## 21-128CP – BSD-SCN – MULTI-TENANT COMMERCIAL BUILDING (4000 W. DUBLIN- GRANVILLE ROAD)

Construction of a ±6,900-square-foot, one-story, multi-tenant commercial building with drive-thru restaurant.

# 1. Context Map

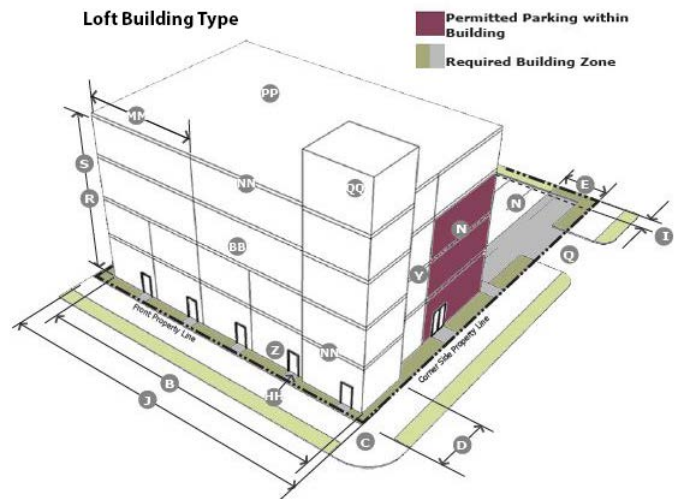
The BSD was created to encourage and develop well-defined, pedestrian-oriented development that is distinct from the typical auto-oriented development (drive-thru uses) in other areas of the City. Auto-oriented development affects the intent for the layout of sites and negatively impacts the access to and safety of pedestrian facilities. Drive-thru uses are generally not encouraged based on the items listed above and have been previously granted only for banks. Staff is not supportive of the proposed accessory use and recommends disapproval of the drive-thru as it is inconsistent with the urban form, is in conflict with the intent and goals of the District as specifically defined in the BSD Code and BSD Special Area Plan and it is unlikely that it could be sufficiently mitigated to meet the Conditional Use review criteria within the context of the BSD. The applicable review criteria are provided in the Commission's packet and also within Zoning Code section 153.236(C).
